COUNCIL ASSESSMENT REPORT

Panel Reference	2018scl028
DA Number	DA-533/2017
LGA	Waverley Council
Proposed Development	Partial demolition of buildings and the construction of a 13 storey mixed use building including 124 residential apartments, 200m ² of retail floor space, a registered club at ground and first floor levels and four levels of basement parking
Street Address	28-34, 36, 38 and 40-42 Bronte Road and 84 Ebley Street, Bondi Junction
Applicant	Capital Bluestone (BJRSL) Pty Ltd ATF the Capital Bluestone (BJRSL) Unit Trust c/- Urbis Pty Ltd
Owner	Bondi Junction – Waverley RSL Sub Branch Club Limit
Date of DA lodgement	12/12/2017
Number of Submissions	51 (includes 27 in support)
Recommendation	Refusal
Regional Development Criteria (Schedule 7 of the SEPP (State and Regional Development) 2011	Clause 3 – General Development that has a capital investment value of more than \$30 million. The Capital Investment value of the proposal is \$65,308,145

Report date	5 July 2018

Figure 5: Sections through the building showing height non-compliance (identified with red line)

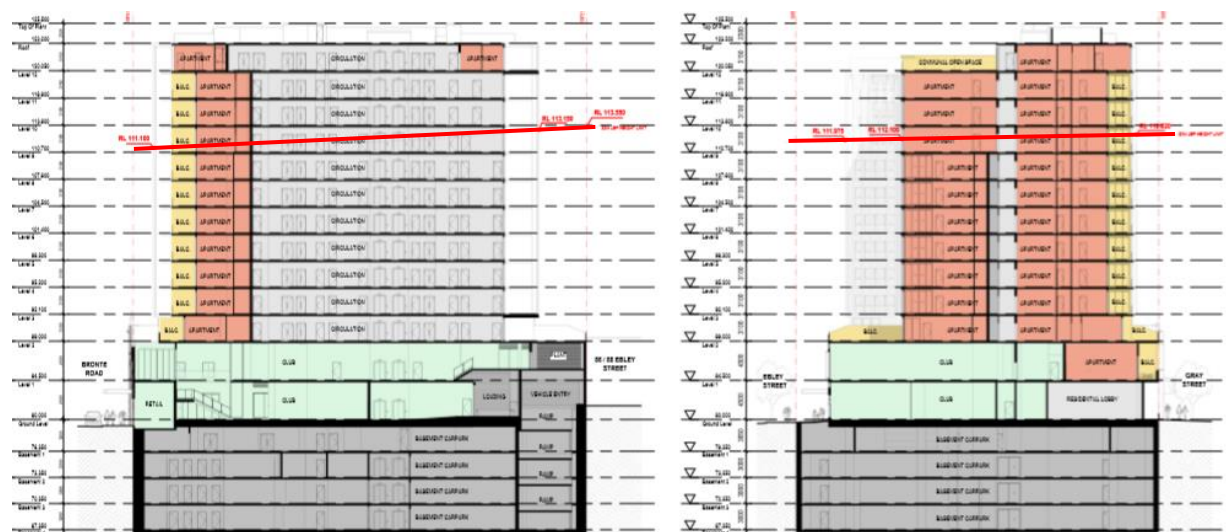
It is argued by the applicant that the height non-compliance occurs due to a number of site constraints including the existing heritage items, a covenant area along the southern boundary and the need to accommodate a similar scale of club operations to that existing on the site. The applicant goes on to argue that the amenity impacts that result are acceptable. The applicant's diagram below

demonstrates the extent of the height non-compliance, as described in the Clause 4.6 submission (refer to Figure 5).

The 32m height limit preserves the current and desired future character of the area. The proposed development seeks to exceed the 32m height control as evident in Figure 5. This is considered to be inconsistent with the current and future context of the surrounding area and is not supported. It is expected that undeveloped sites in the future would be similarly required to comply with the 32m maximum building height, and this is the consistent character of this area which seeks to provide a suitable transition between the Bondi junction core and the adjacent lower density residential areas to the east, south-east and south west of the subject site.

Figure 6: Winter solstice shadow analysis

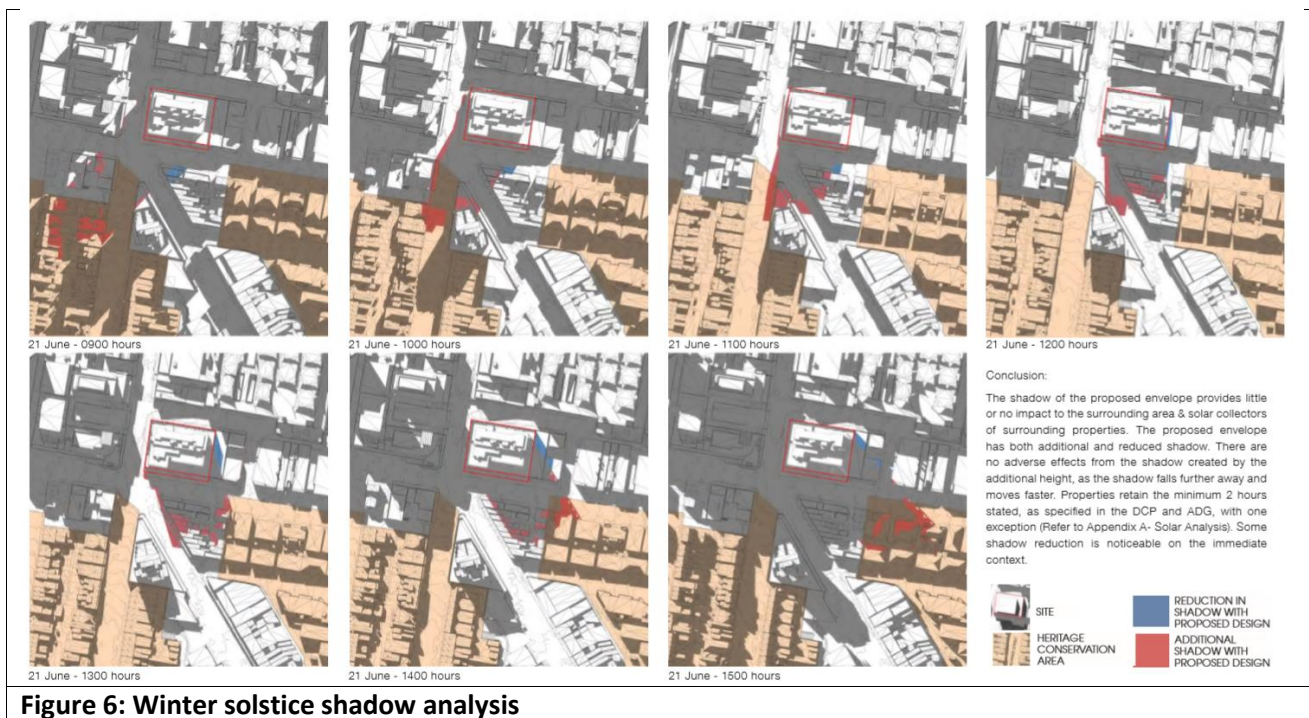
The proposal will adversely affect the solar access provisions to adjacent properties, particularly those located to the south-west and south-east of the site in the low density residential heritage conservation areas. In particular, the proposed envelope has a substantial impact on solar access to the adjacent properties at 91 and 93 Ebley Street. With the proposed envelope, the mentioned properties would have a minimum of 25 and 60 minutes of solar access, respectively, which is not acceptable.

Figure 7: Cross ventilation diagrams

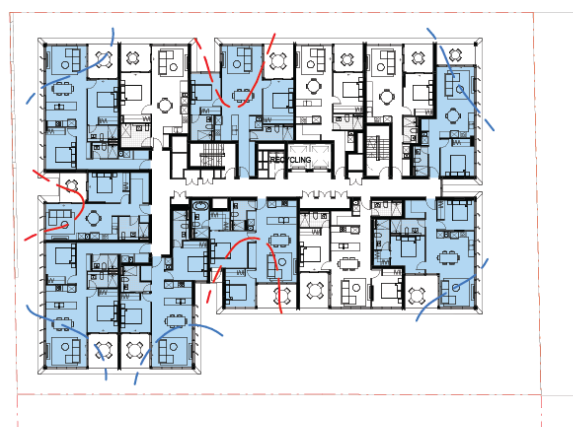
- *Cross ventilation is achieved by apartments having more than one aspect with direct exposure to the prevailing winds, or windows located in significantly different pressure regions, rather than relying on purely wind driven air (ADG 4B).*
- *The diagrams for Levels 2 and 3 to 8 show 2 and 3 cases that don't abide to the best practice described above (see figure 7). Consequently, the proposed building does not meet the minimum of 60% of apartments within the first 9 storeys with natural cross ventilation.*
